By TMayberry at 6:03:01 PM, 7/19/2022

I-25 & WIGWAM FA#: 10099192 SBA SITE#: CO46077

GENERATOR INSTALLATION PROJECT 30KW KOHLER DIESEL GENERATOR

SHEET NUMBER:
A-1

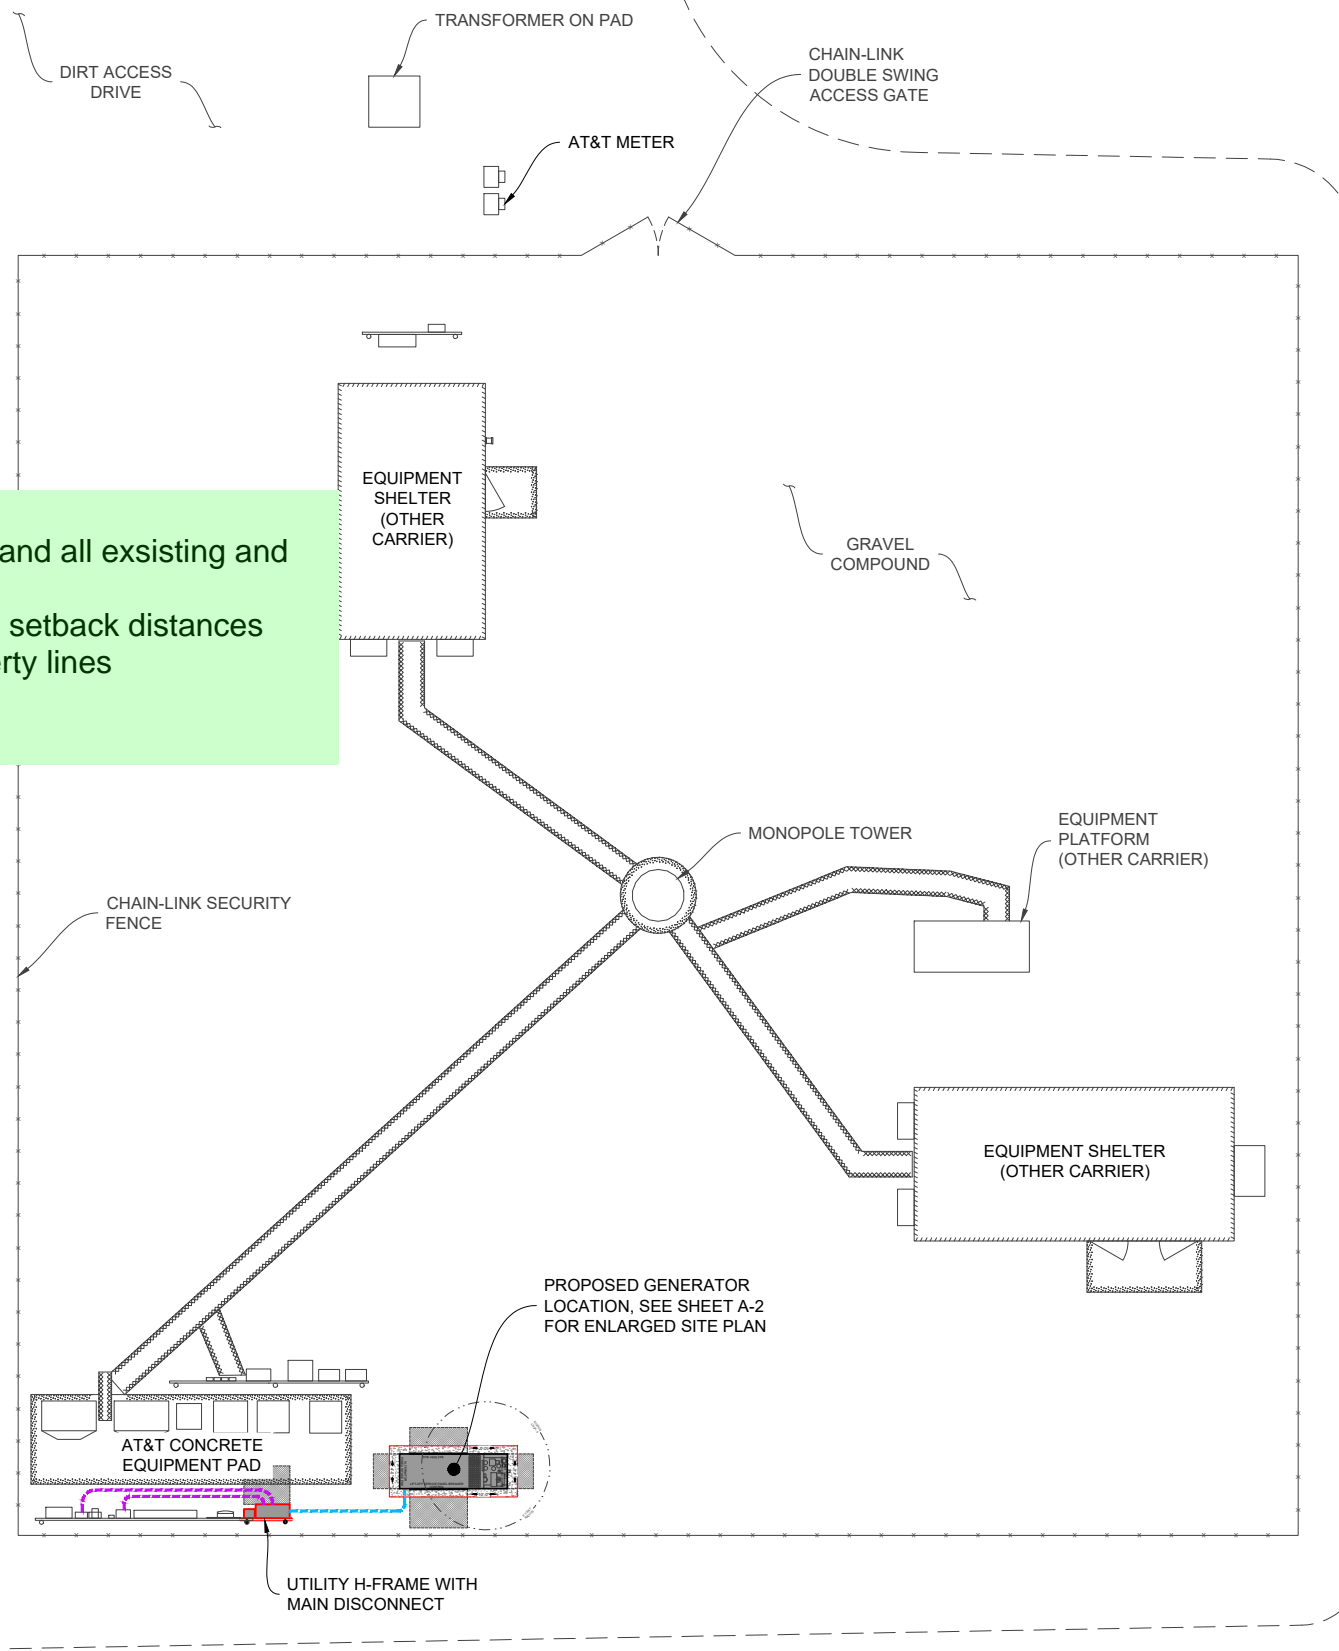
Please add:
 -location and dimension of property lines, rights of way, and all existing and proposed easements
 -footprint of all existing and proposed buildings and the setback distances from each existing and proposed structure to the property lines
